Addendum #2

RE: QUESTIONS & ANSWERS, SPECIFICATIONS, DRAWINGS AND DOCUMENTS

Project
SICKKIDS - 7A SCHEDULE - 1BEDS REFRESH
ATRIUM (SLAUGHT) WING, 170 ELIZABETH STREET, TORONTO, ON, M5G 1E8

2 LIGHTING FIXTURE SCHEDULE
SCALE: N.T.S.

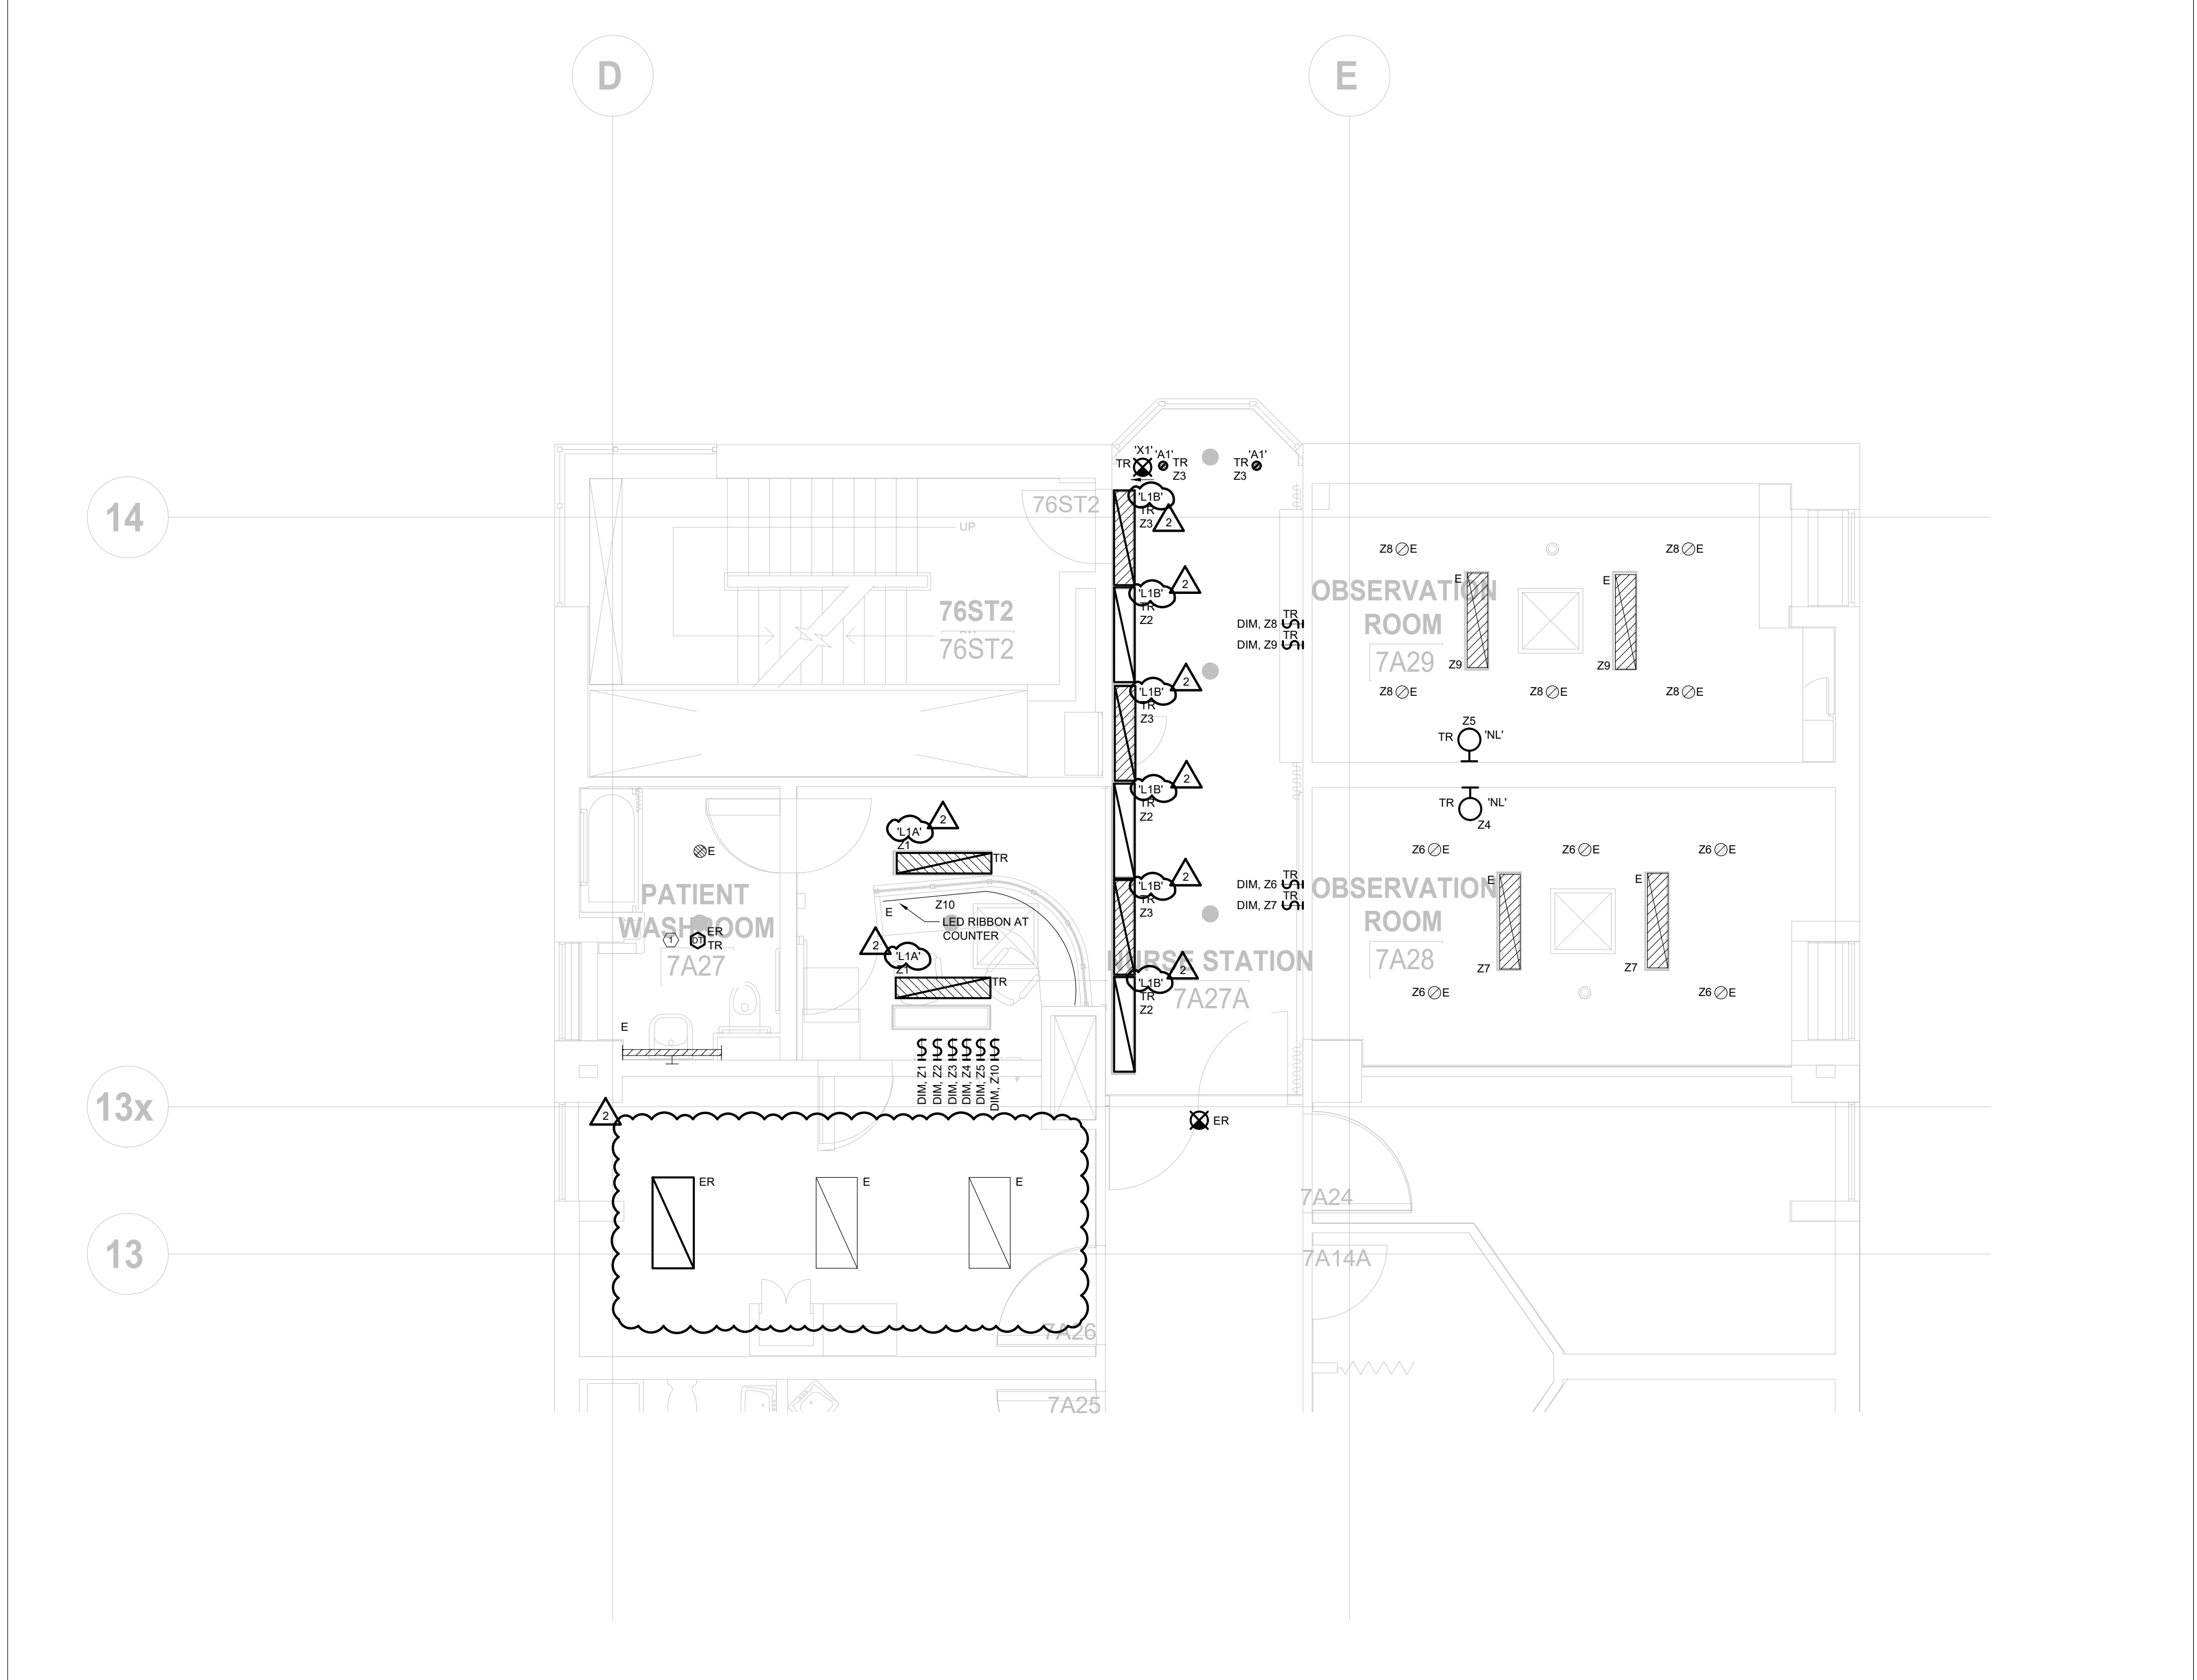
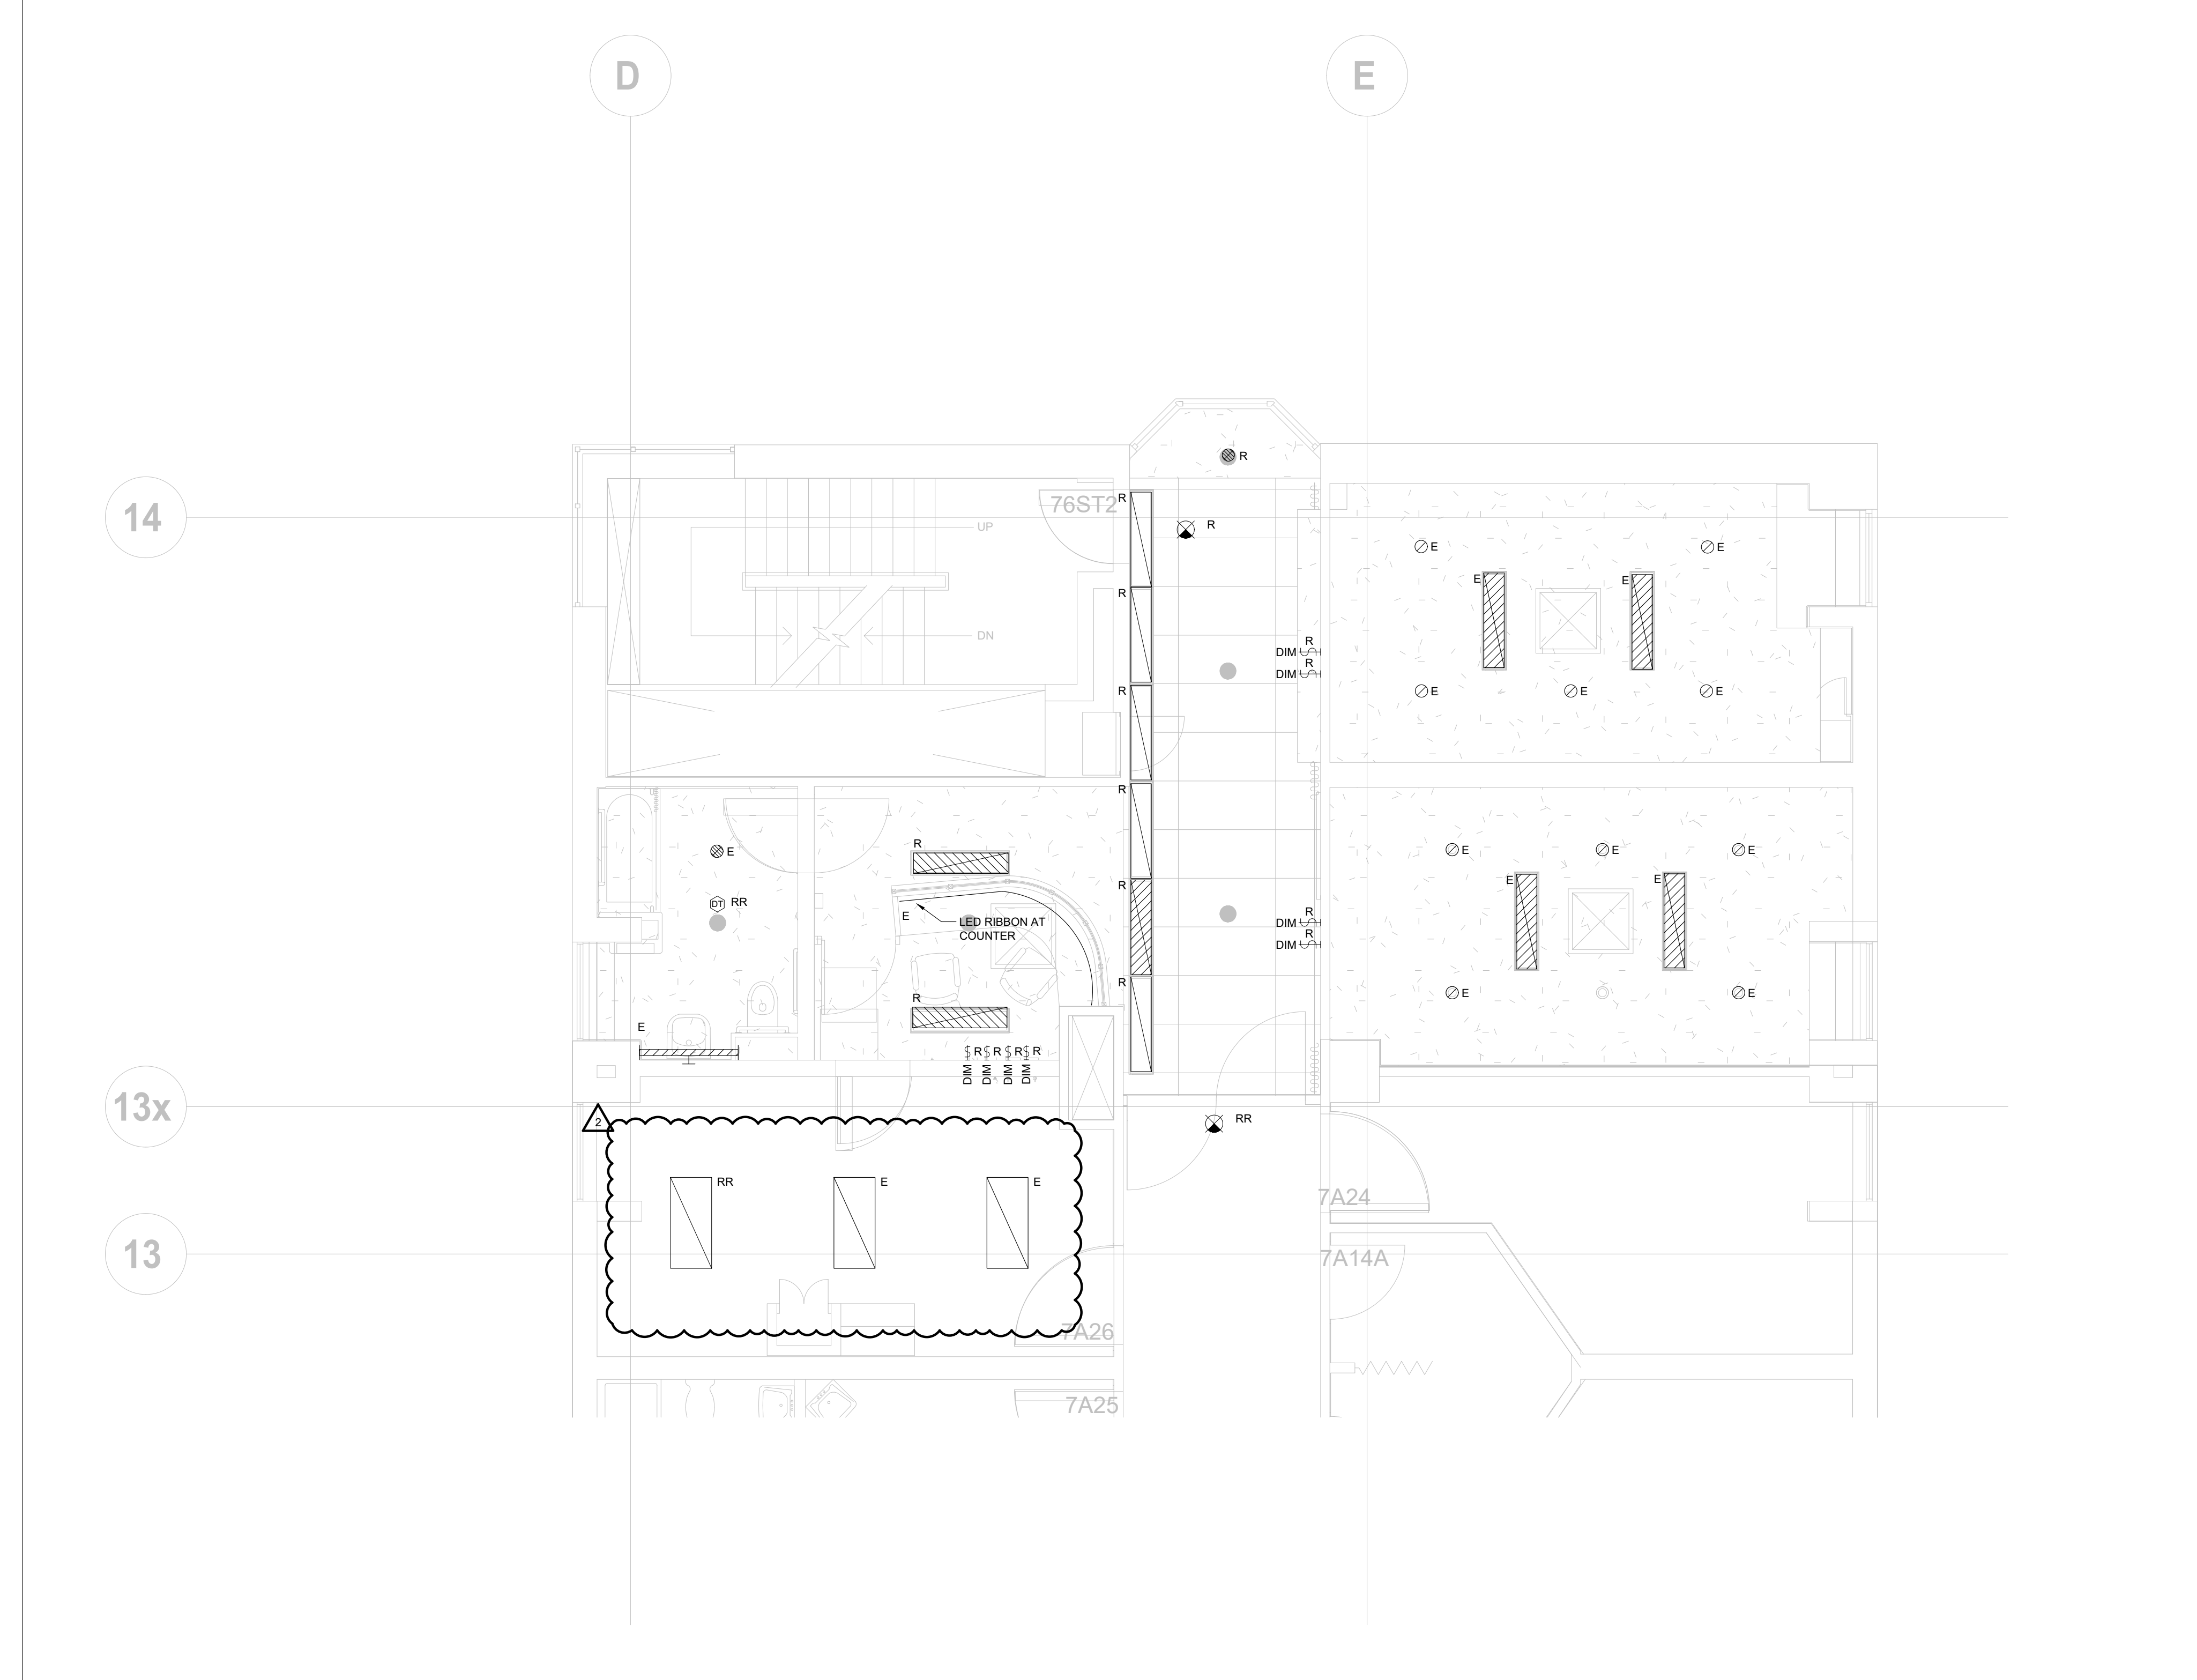
Q37- On drwg EL 07 AN 01 detail #2 lighting fixture schedule, confirm the 2 light fixtures for the Nurses’ station are L1A & the 6 in the corridor are L1B this isn’t shown on the drwg?

A37- Confirmed, clarification to tags will be added as part of Addendum E1.
